**EXPLANATION OF SIGNIFICANT DIFFERENCES
FOR THE 300-FF-2 OPERABLE UNIT RECORD OF DECISION**

May 2004

USDOE Hanford 300 Area
300-FF-2 Operable Unit
Hanford Site
Benton County, Washington

Figure 1. 300 Area Waste Site Groups Identified for Unrestricted Use Cleanup.

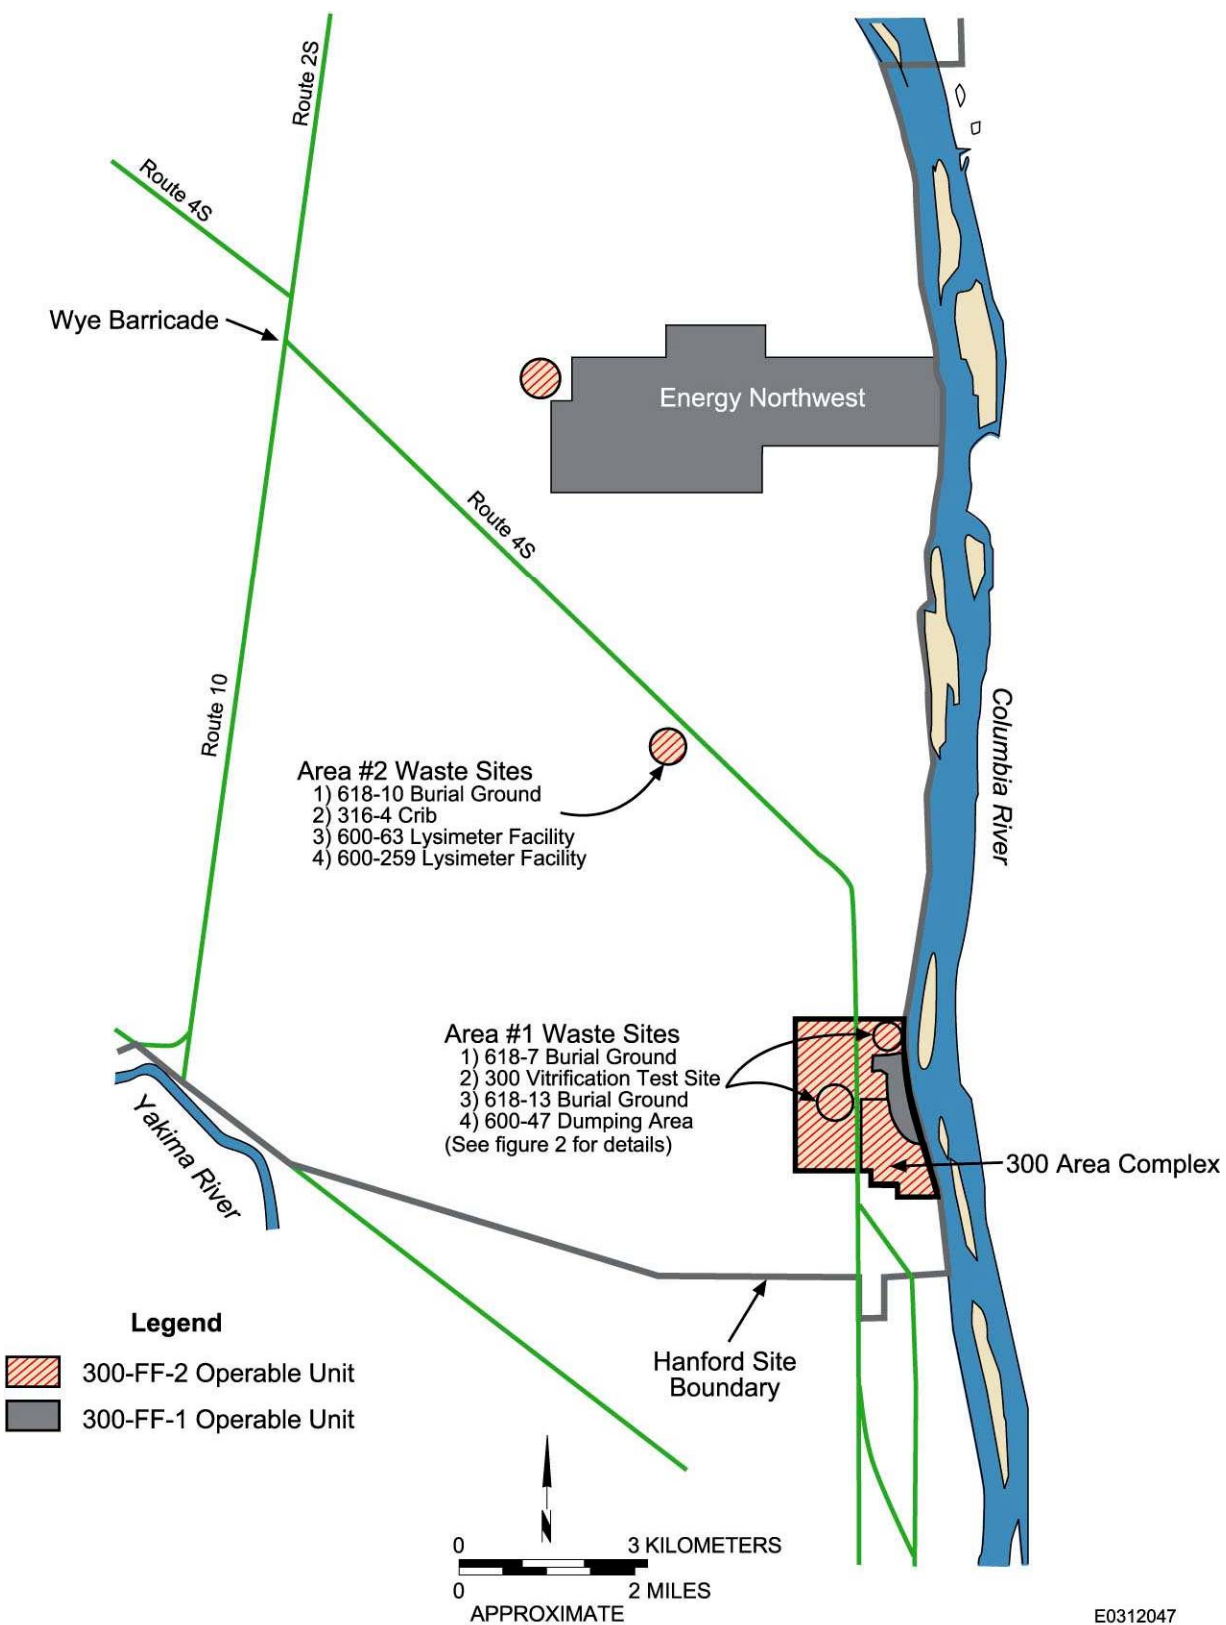
Change 2: Modify the soil cleanup levels for eight outlying waste sites. The 300-FF-2 ROD concluded that the reasonably anticipated future land use would be industrial for the entire 300-FF-2 Operable Unit (OU), which was based on available land-use planning documents and was the basis for the industrial cleanup levels. Further evaluation by the Tri-Parties concluded that a change in cleanup levels would be appropriate for eight specific outlying waste sites in order to reduce the long term costs of institutional controls and allow other beneficial uses of these outlying areas. The location of these waste sites is depicted in Figure 1 and Figure 2. The revised cleanup levels are based on the 100 Area rural residential exposure scenario, commonly referred to as unrestricted, and are listed in Tables 1 and 2.

In addition, the Tri-Parties have agreed that unrestricted use soil cleanup levels for eight waste sites would be appropriate in the 300-FF-2 OU, that are located outside the 300 Area “core industrial zone area” (see Figures 1 and 2). An ESD is necessary to change the cleanup levels for these eight specific outlying waste sites.

Change 2: Modify the soil cleanup levels for eight outlying waste sites.

The key assumptions in the 300 Area unrestricted land-use scenario that affect the groundwater protection determination are irrigation at agronomic rates (76 cm/yr [30 in./yr]), surface vegetation resulting in an evapotranspiration coefficient of 91%, and the change in the exposure pathway to include drinking water ingestion. Based on the unrestricted land-use scenario described above, the cleanup levels to be used for the eight waste sites are listed in Tables 1 and 2.

Figure 3. Solid Waste Uranium Groundwater Protection Assessment Model.

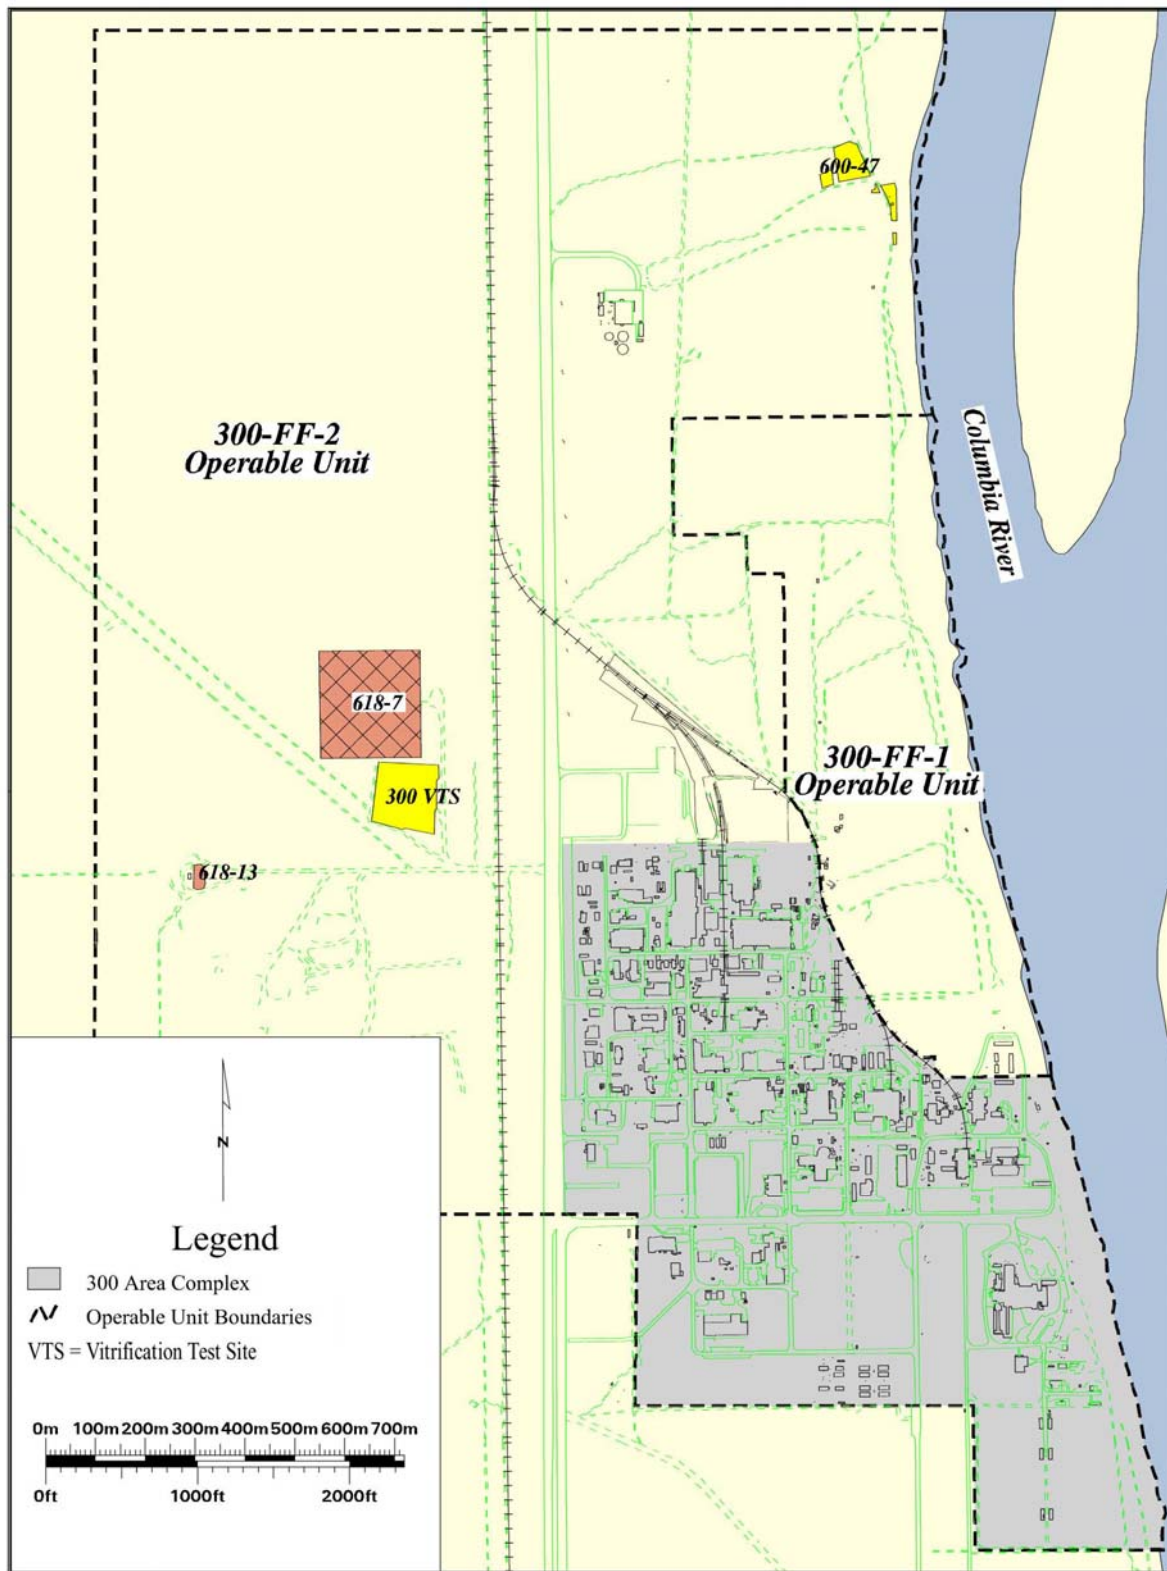
The old and the new conceptual models are shown in Figures 3 and 4.

A revision has been made to the conceptual site model (see the “Analysis of Results and Revision of Conceptual Site Model” section for a description of the old and new conceptual models), which is used to evaluate compliance with the RAOs specified in the 300-FF-2 ROD (EPA 2001) for cleanup actions to be protective of groundwater and surface water quality. The change is to use K_d values and a revised conceptual site model that is representative of the observations made during the PNNL leach test/ K_d study (PNNL 2002).

The most conservative K_d values of 8.9 mL/g for the desorption phase of the contaminated zone, and 0 mL/g for the adsorption phase of the uncontaminated zone and saturated zone respectively, were selected to be the K_d values used to assess the protectiveness of residual contamination following remediation.

A RESRAD assessment of site-specific residual uranium soil concentrations for groundwater protection was performed using new K_d values (8.9 mL/g for the contaminated zone, 0 mL/g for the uncontaminated zone, and 0 mL/g for the saturated zone). In addition, the approaches developed in the *Remedial Design Report/Remedial Action Work Plan for the 300 Area* (RDR/RAWP) (DOE-RL 2002b) for cleanup verification of solid and liquid waste disposal sites were also applied. The RESRAD calculations used the applicable land-use scenario (industrial, without irrigation), soil characteristics, and hydrogeologic inputs. The model calculated the concentrations in groundwater, and then these concentrations were compared to the drinking water standard maximum contaminant level (MCL) of 30 µg/L (20.8 pCi/L) for making decisions on whether residual contamination levels are protective of groundwater. The model predicts that 267 pCi/g of uranium in soil is protective of groundwater at the drinking water MCL standard and of the Columbia River.
